**CPED STAFF REPORT**  
Prepared for the City Planning Commission

CPC Agenda Item #5  
April 7, 2014  
BZZ-6454

*Property Location:* 81 St. Anthony Parkway  
*Project Name:* Alliance Steel Services  
*Prepared By:* [Hilary Dvorak](#), Principal Planner, (612) 673-2639  
*Applicant:* G&G Real Estate, LLC  
*Project Contact:* Jeffery Ellerd with Wenck Associates  
*Request:* 15,000 square foot addition to an existing recycling facility  
*Required Applications:*

SHEET TITLE PROPOSED SITE IMPROVEMENTS			
DWN BY JVB	CHK'D JE	APP'D JE	DWG DATE NOV 2013
PROJECT NO. 0258-52	SHEET NO. C-103	SCALE AS SHOWN	REV NO. 2

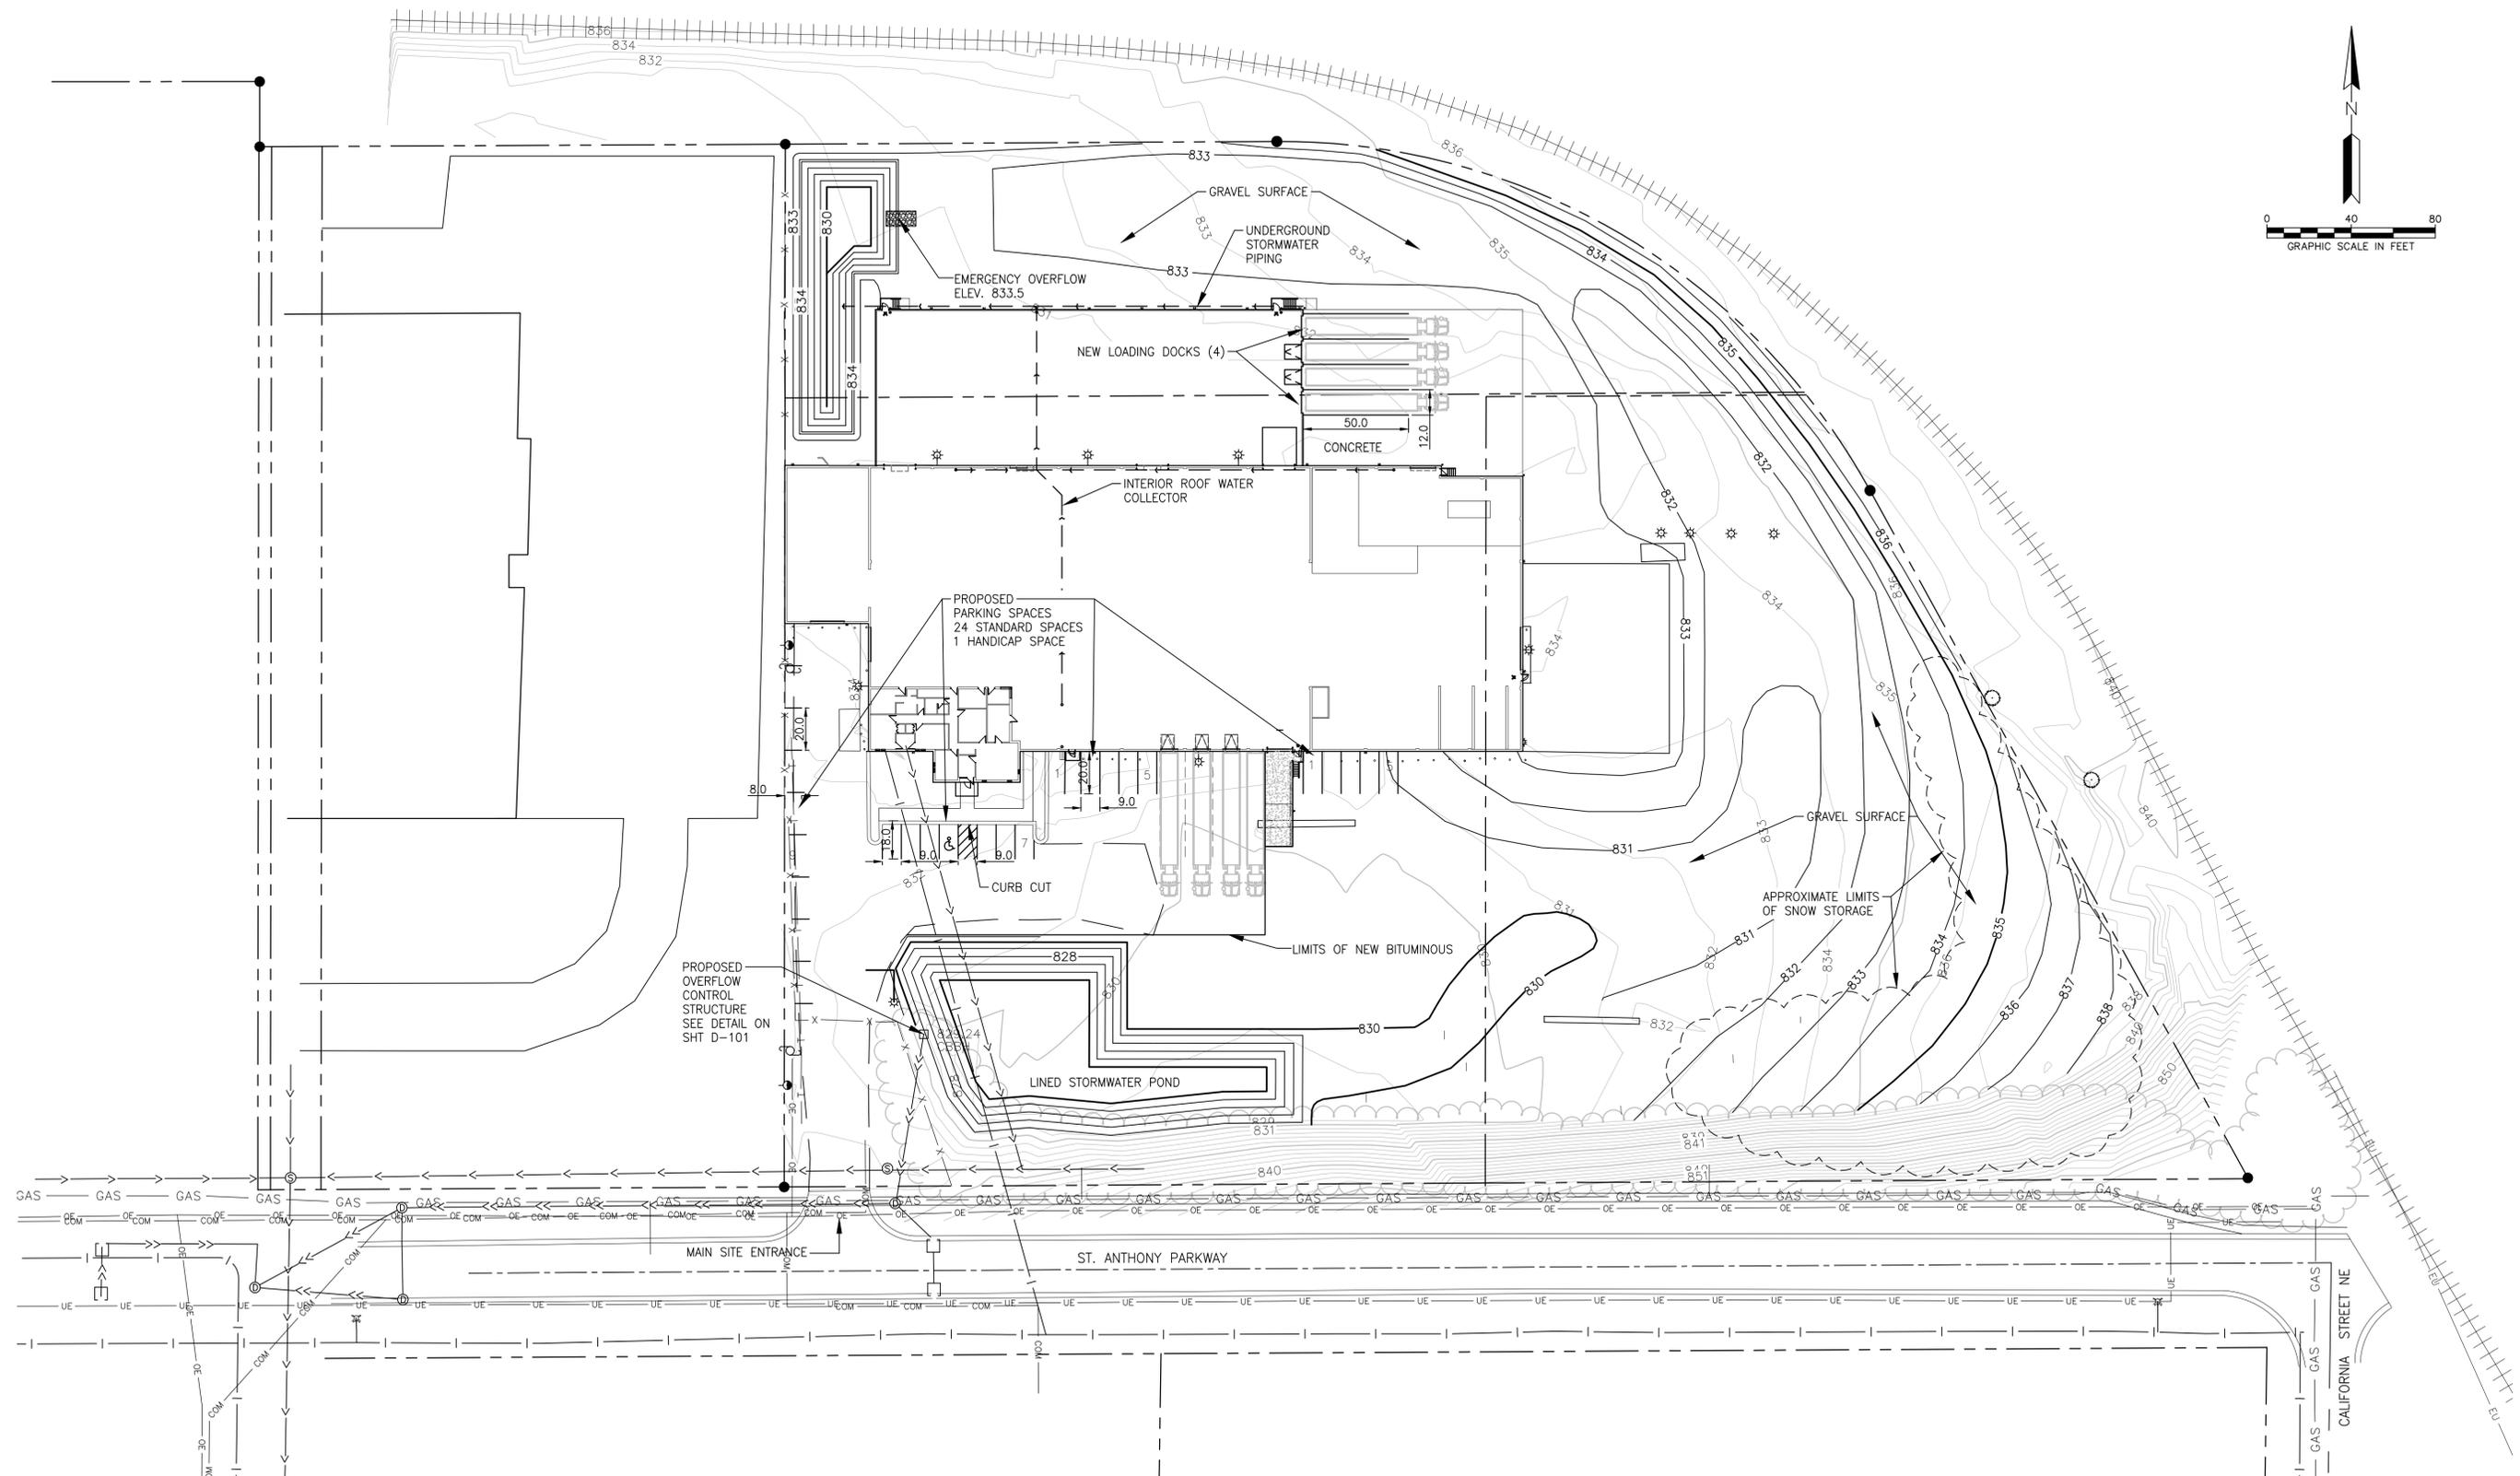
- It is unclear what portion, if any, of the existing storm sewer from the site is being reconstructed. Please identify the proposed improvements to the storm sewer on the plans.

- As was previously discussed, it is the City's understanding that the south pond is proposed to be lined to prevent infiltration due to the use of the site. If this is the case, please note this on the plans along with details regarding the liner material. Please also include the NWL and HWL of the pond on the plans.

- It is recommended that notes be added to the plans identifying the construction procedure for the infiltration feature to ensure it is properly constructed.

- Please correct the proposed contours in the northwest portion of the site, as they do not appear to tie in properly with the existing. Spot elevation along the building addition perimeter should also be identified on the plans to ensure proper drainage away from the building.

SHEET TITLE			
LANDSCAPE PLAN			
DWN BY	CHK'D	APP'D	DWG DATE
CMS	JE	CMS	FEB 2014
PROJECT NO.		SCALE	AS SHOWN
0258-52		L-100	
SHEET NO.		REV NO.

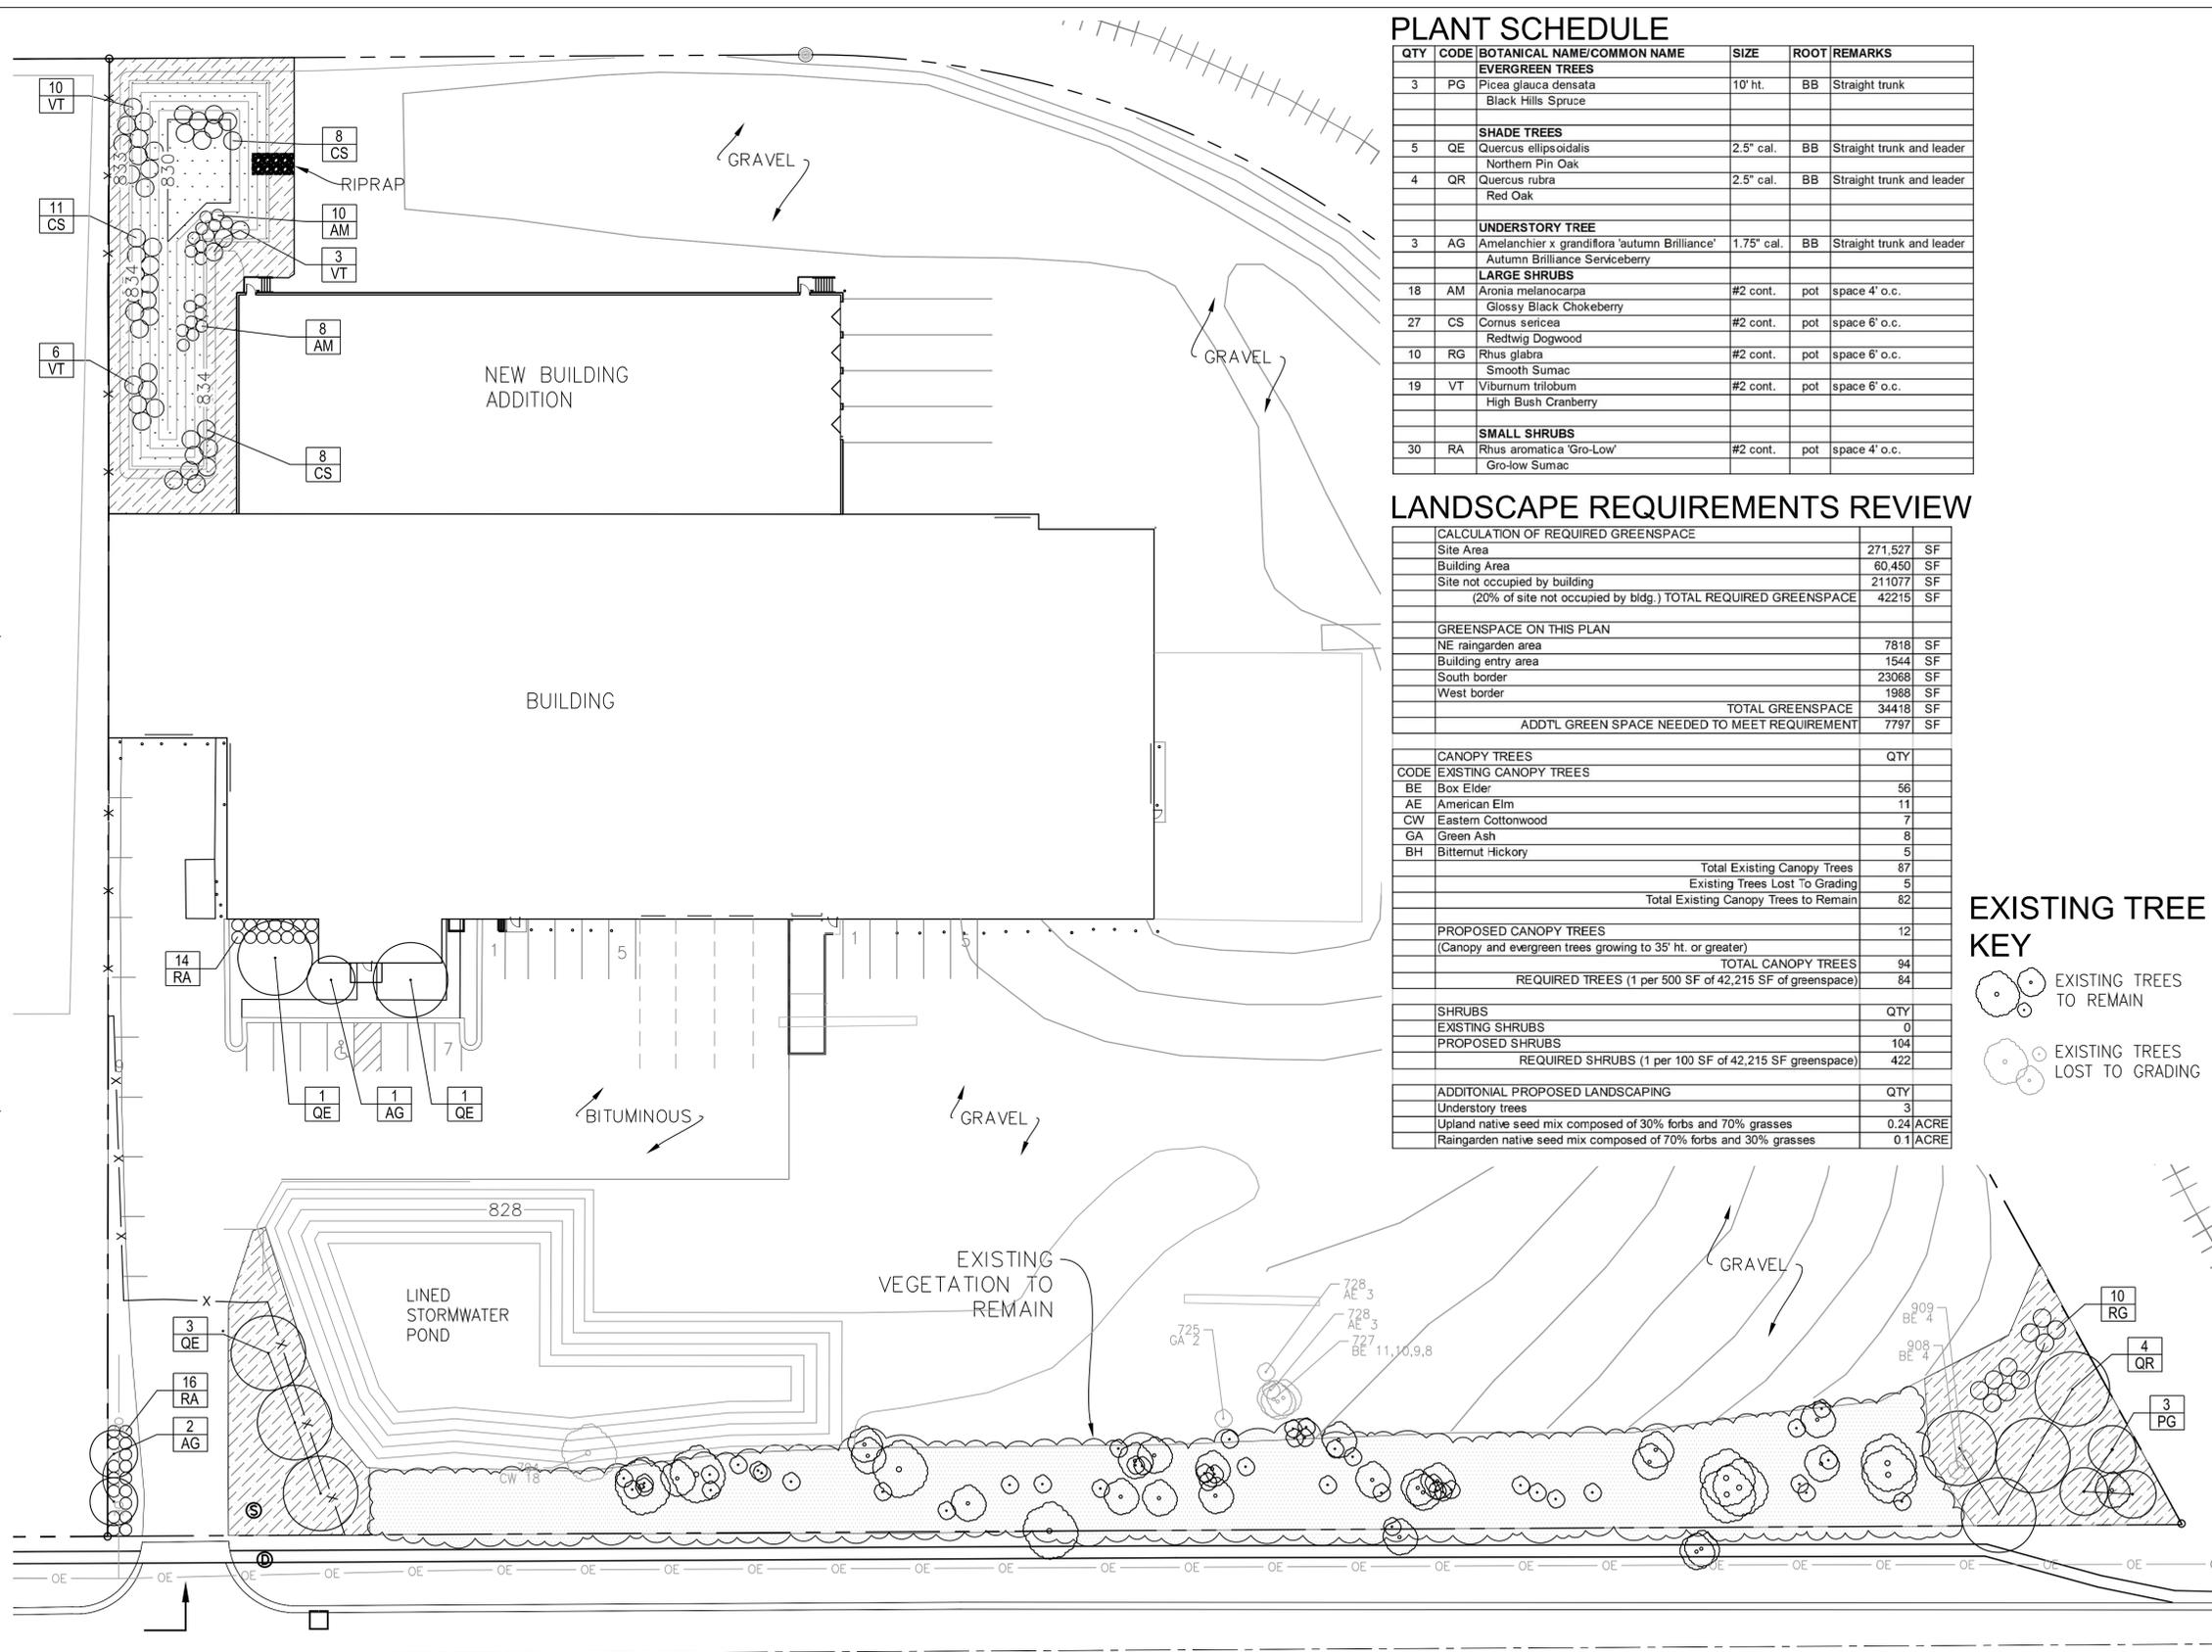
3. A minimum of 20 evergreen trees shall be planted on the site.
4. The “Al Johnson Trucking” sign located near the entrance gates to the site shall be removed.
5. As part of the container management plan the applicant shall designate an area for the trash dumpster. It shall be screened per the requirements of section 535.80 of the zoning code.
